RE: 186 Grove St, Site Plan Review – Peer Review Comments

**Re: 186 Grove Street  
Site Plan Peer Review**

BETA Group, Inc. has reviewed revised documents for the proposed Site Plan Application, "Proposed Site Improvements – 186 Grove Street, Franklin, MA." This letter is provided to update findings, comments, and recommendations.

**RE: Site Plan Modification Review – 186 Grove St**

1 LEACHING BASIN DETAIL  
NOT TO SCALE

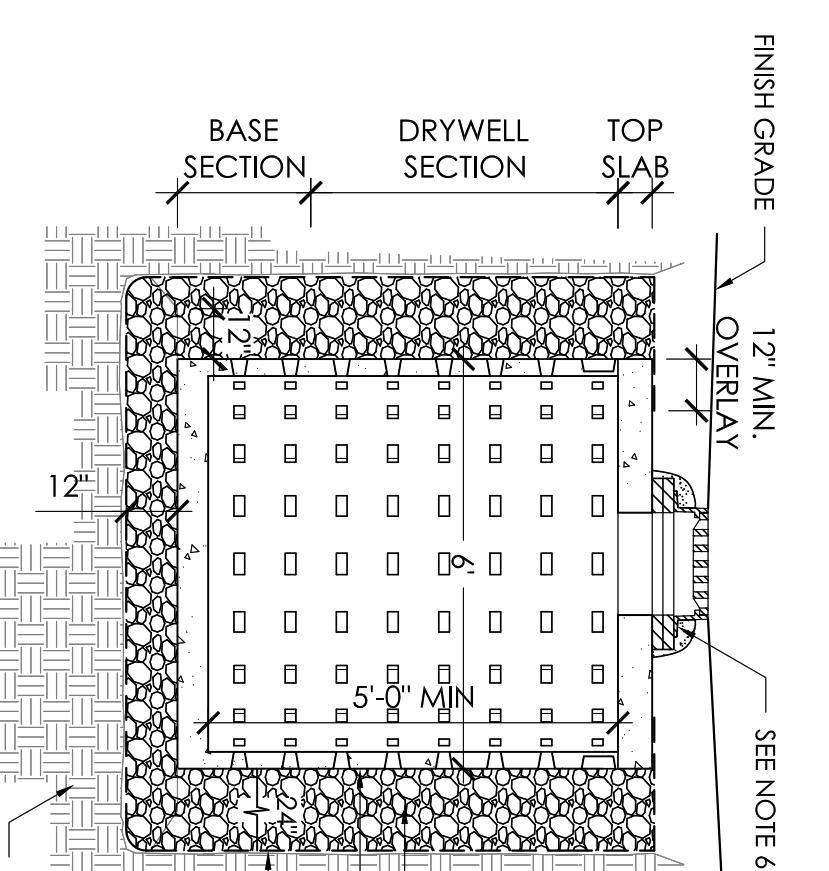
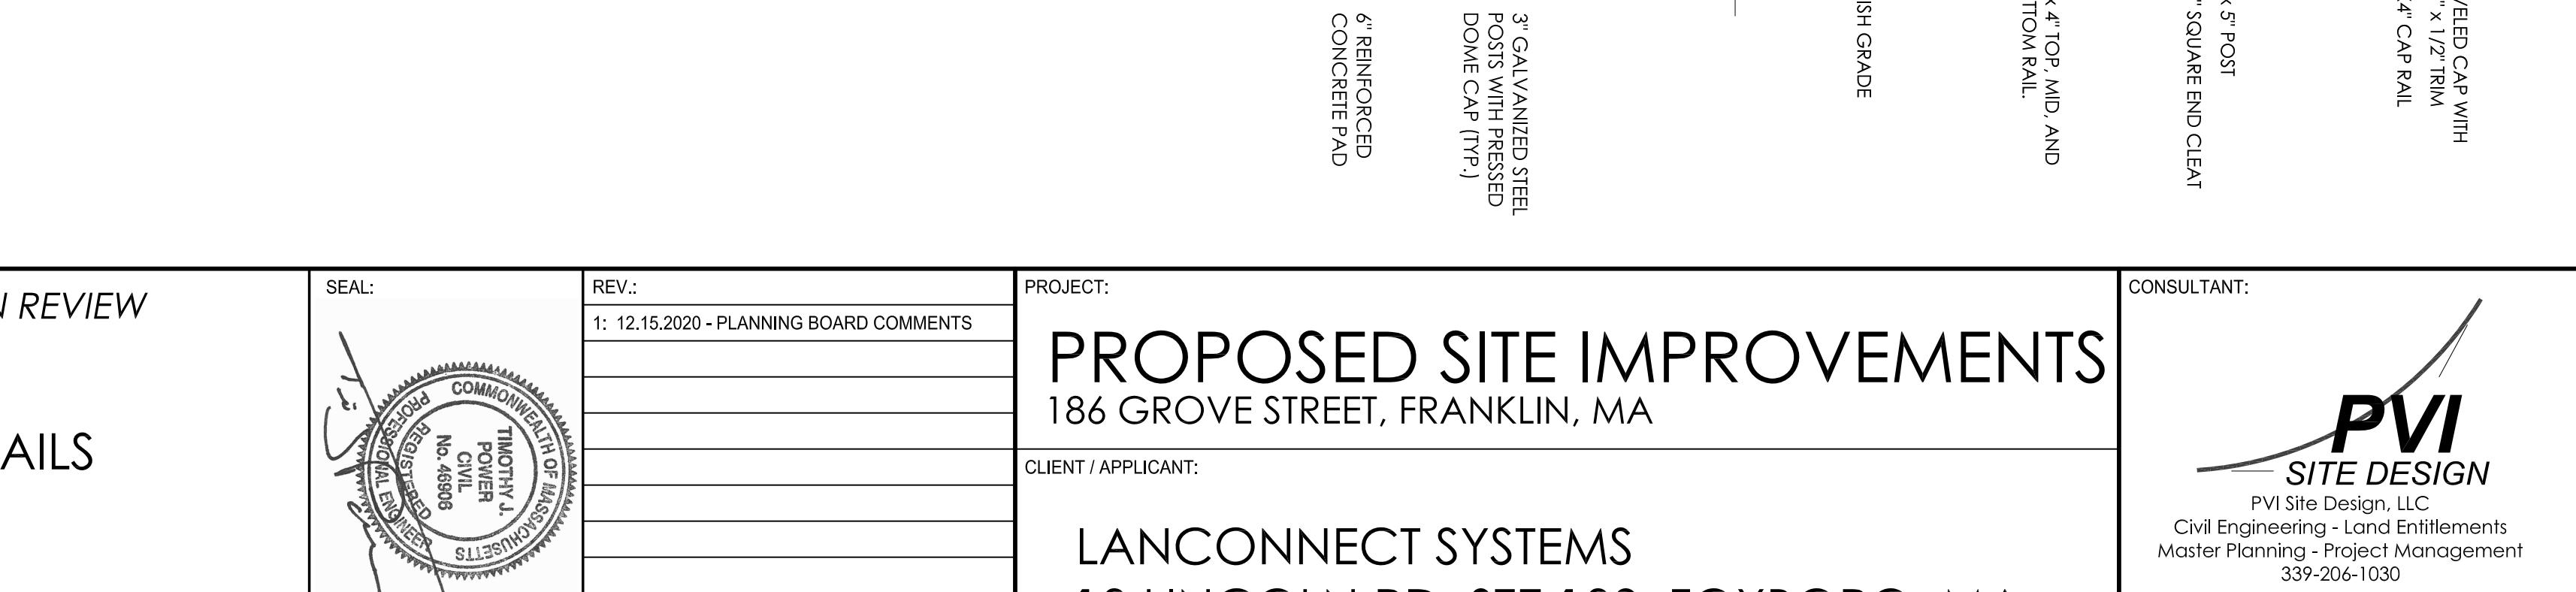
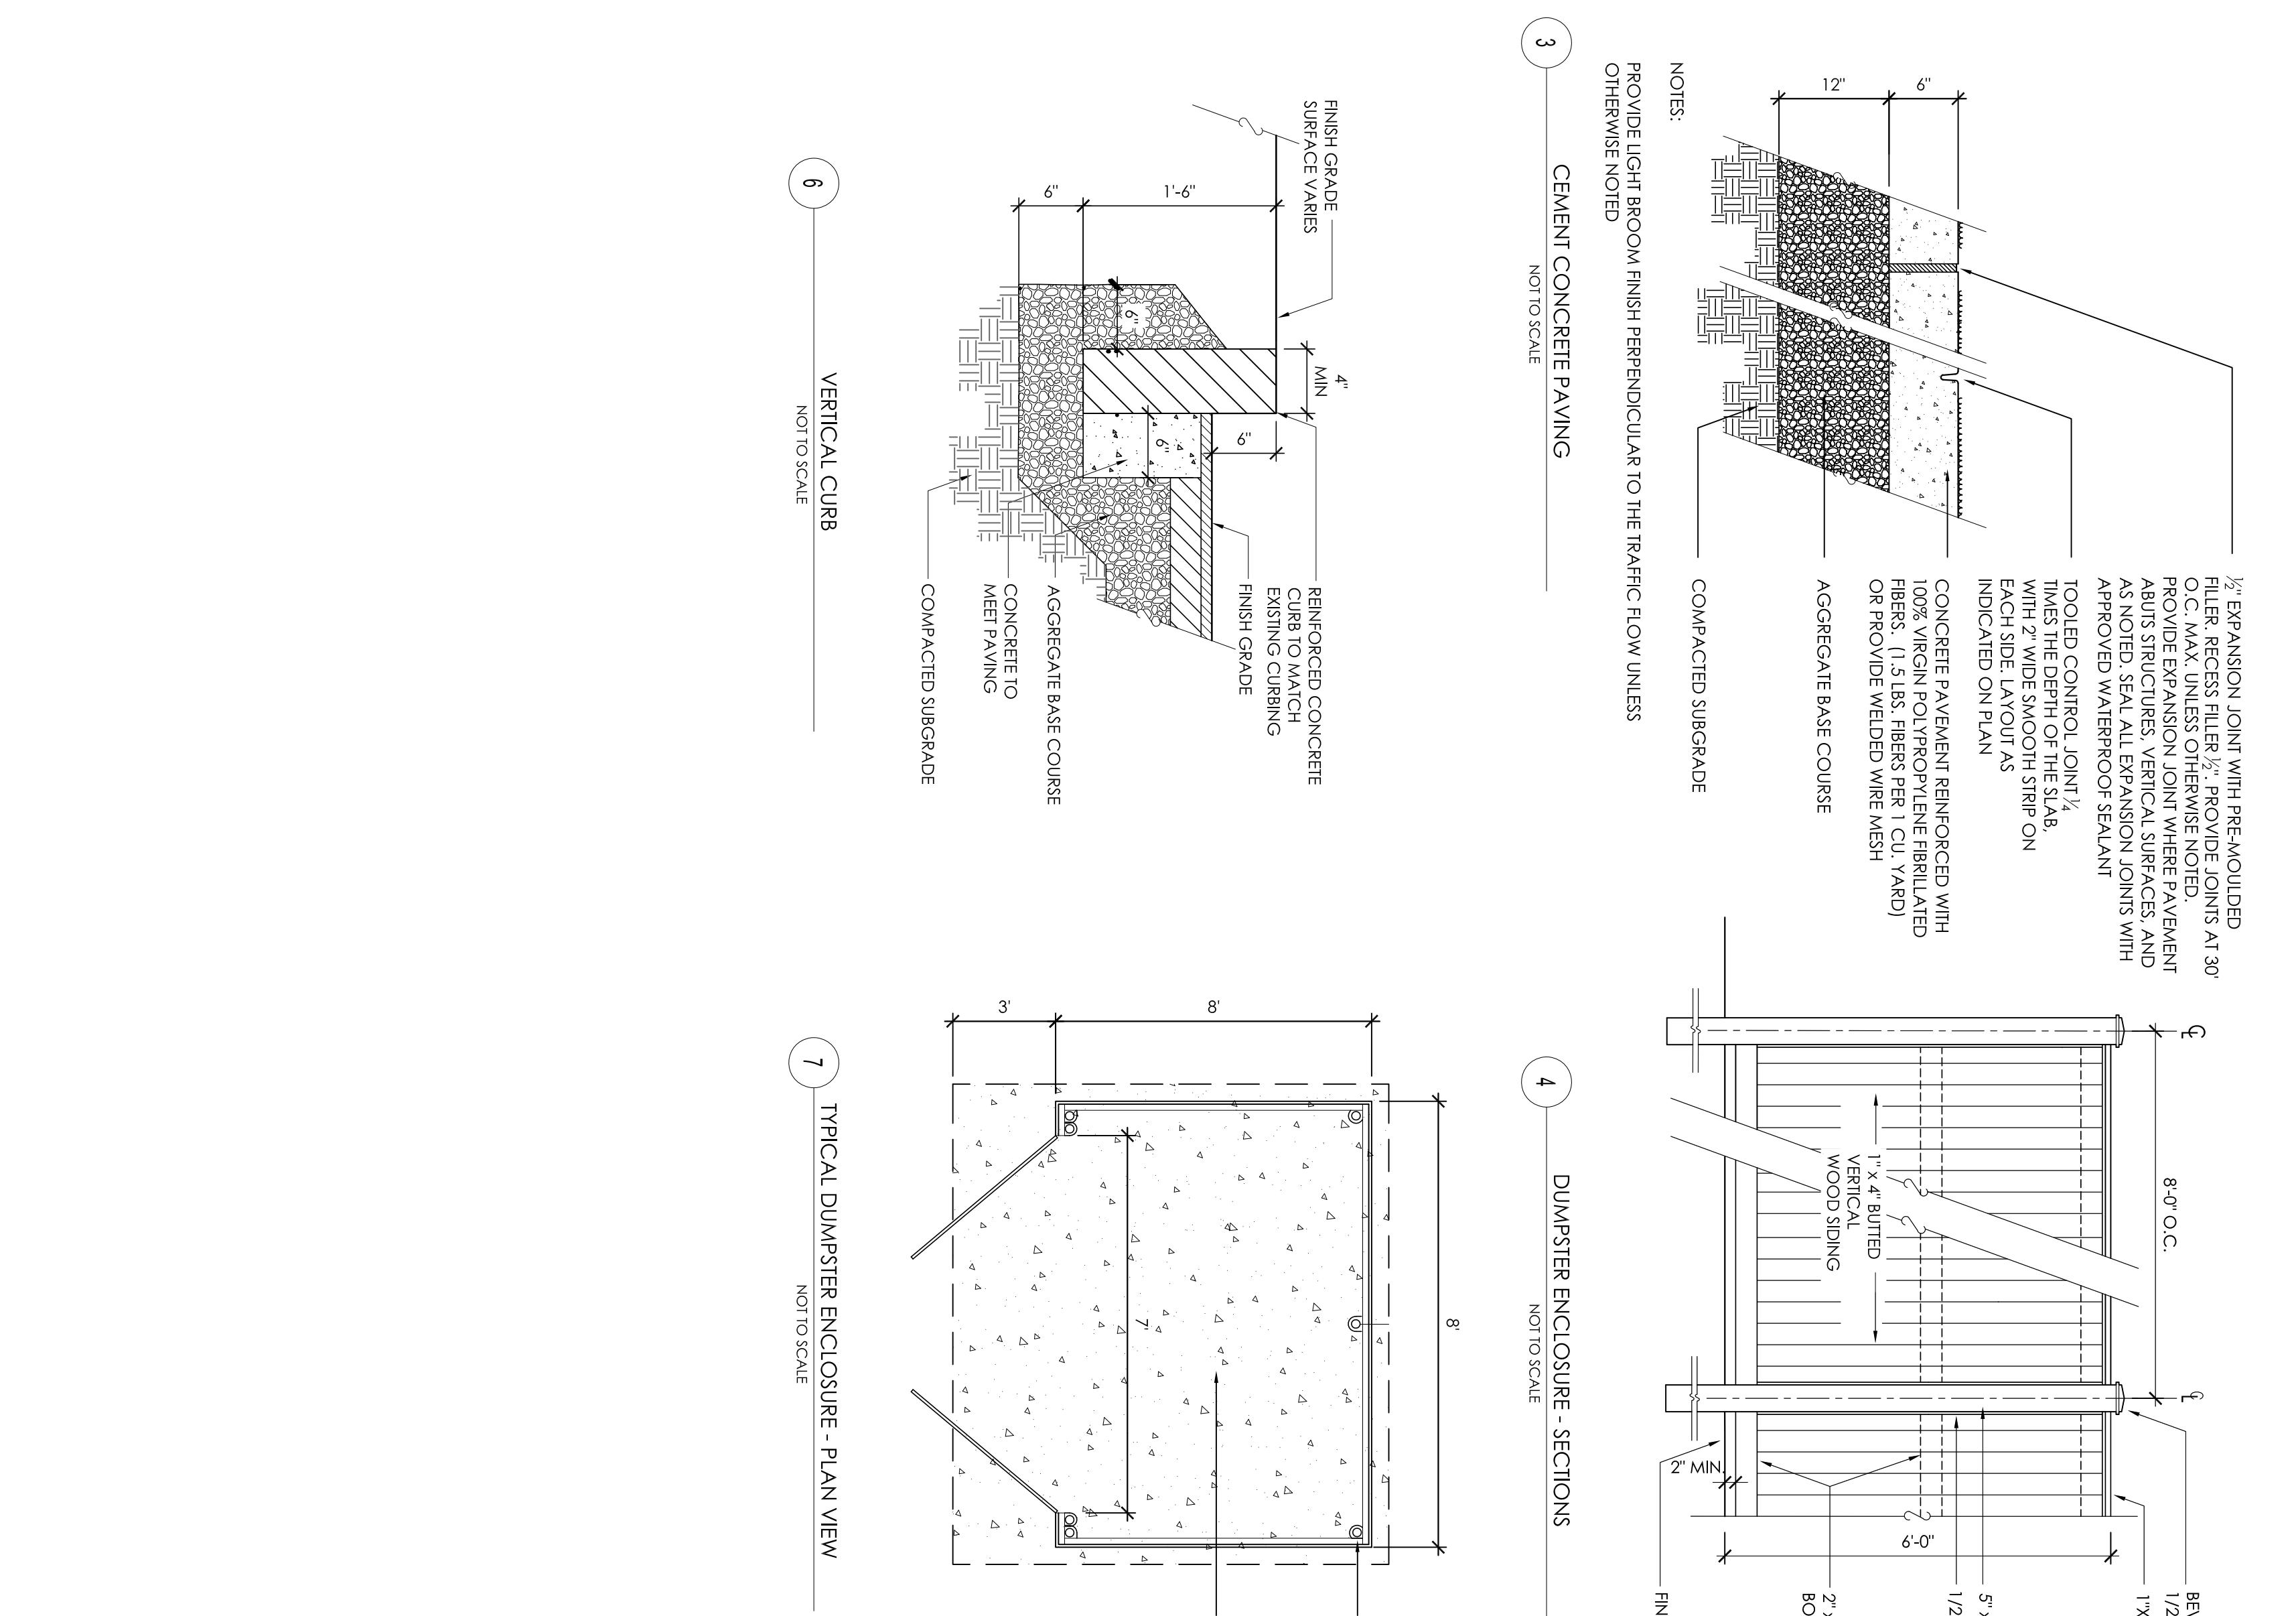
SW1. Clarify if a pipe connection (recommended) is proposed between the two leaching basins.

- SW1. Clarify if a pipe connection (recommended) is proposed between the two leaching basins. *PVI: The plans have been revised to proposed a pipe between the two leaching structures.* **BETA2: At the discretion of the Board revise the proposed PVC pipe to RCP. BETA notes the proposed pipe is located outside of any areas subject to traffic loading.**

***The plans have been revised to propose a pipe between the two leaching structures.***
